ENVIRONMENTAL STATEMENT

INT FES 79 - 60

SALT-GILA AQUEDUCT A FEATURE OF CENTRAL ARIZONA PROJECT

PREPARED BY
DEPARTMENT OF THE INTERIOR
BUREAU OF RECLAMATION
LOWER COLORADO REGION

Figure 59
VEGETATION TYPES
SALT-GILA AQUEDUCT
CENTRAL ARIZONA PROJECT

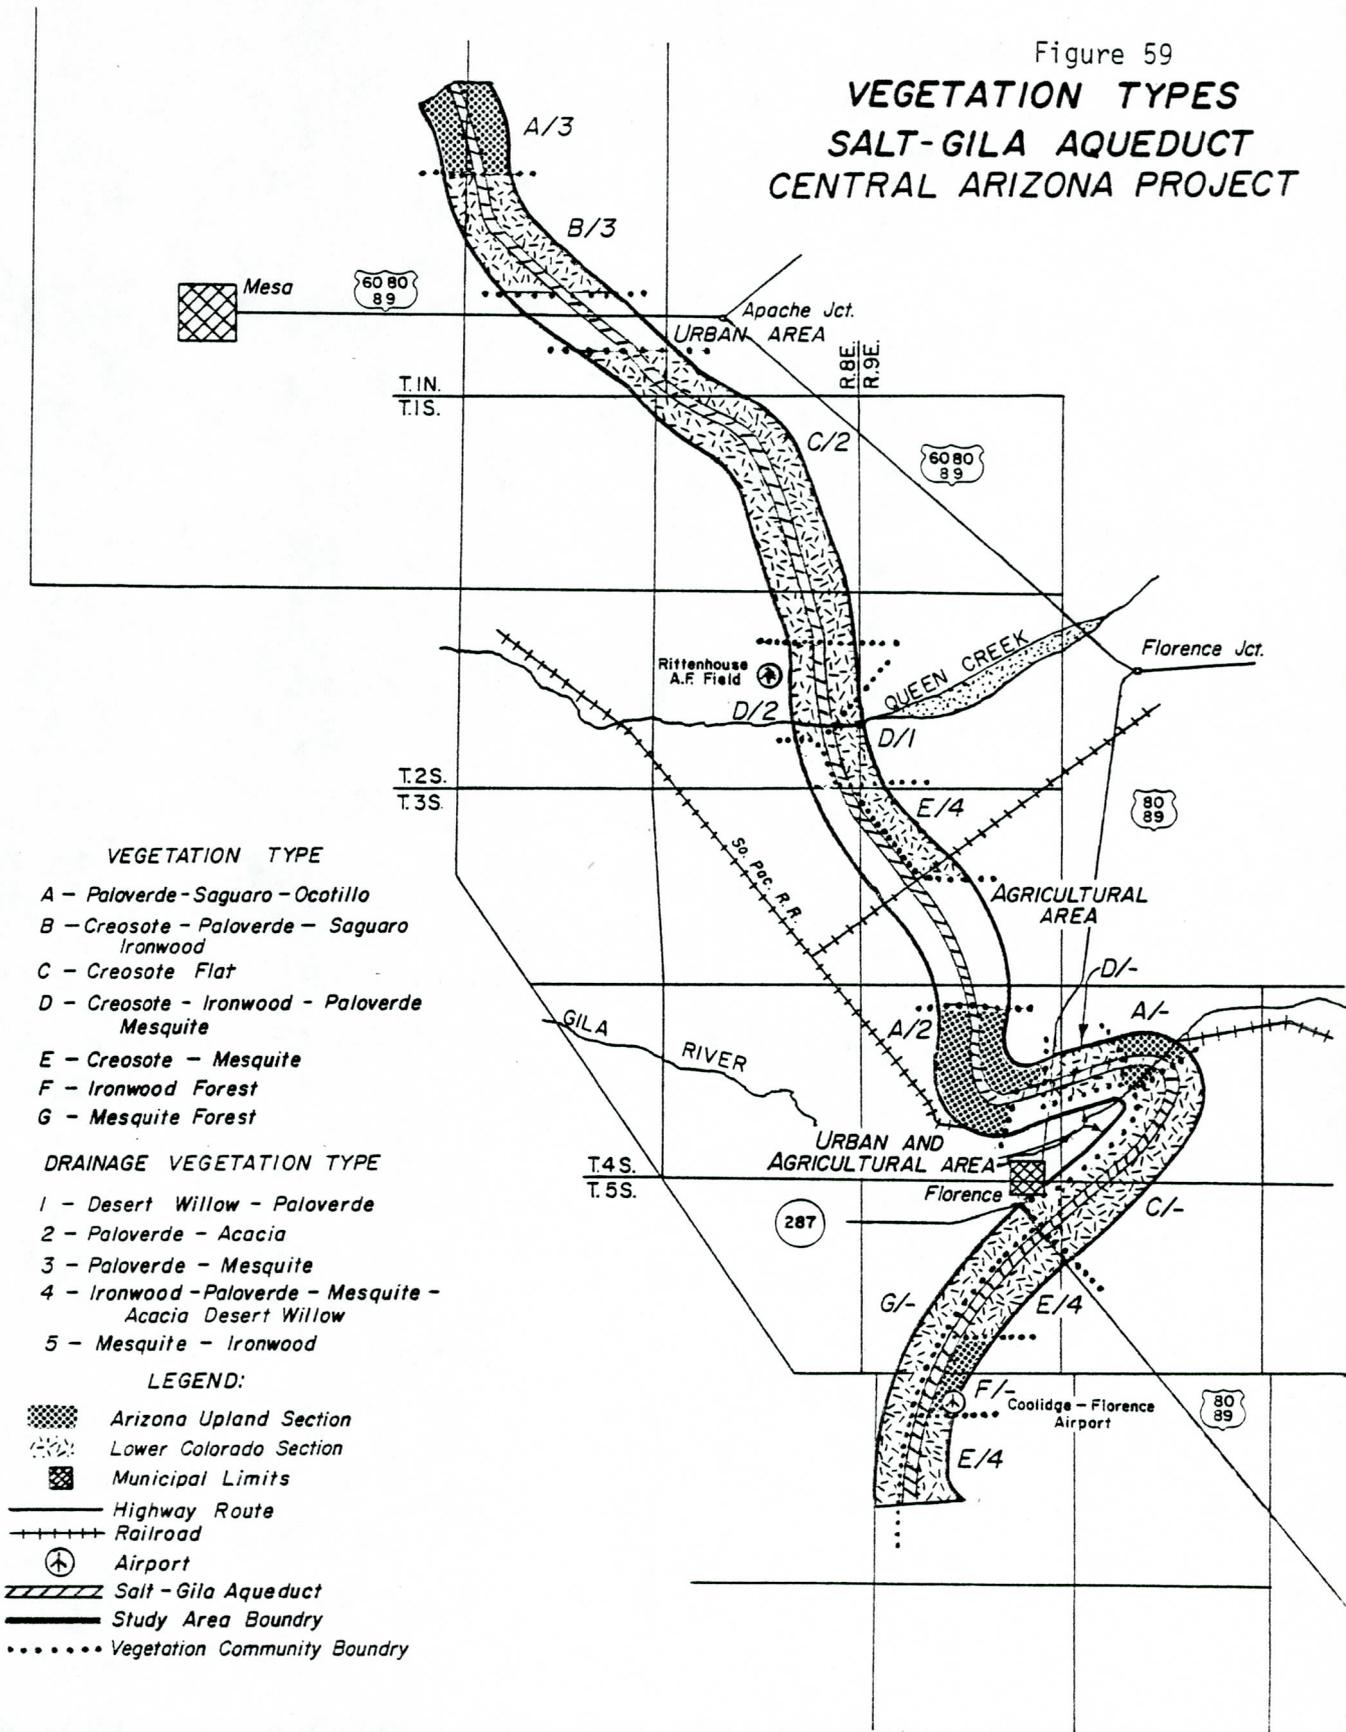
Fol. Figure 59. - The vegetation types in this figure do not correspond directly to the plant community discussions.
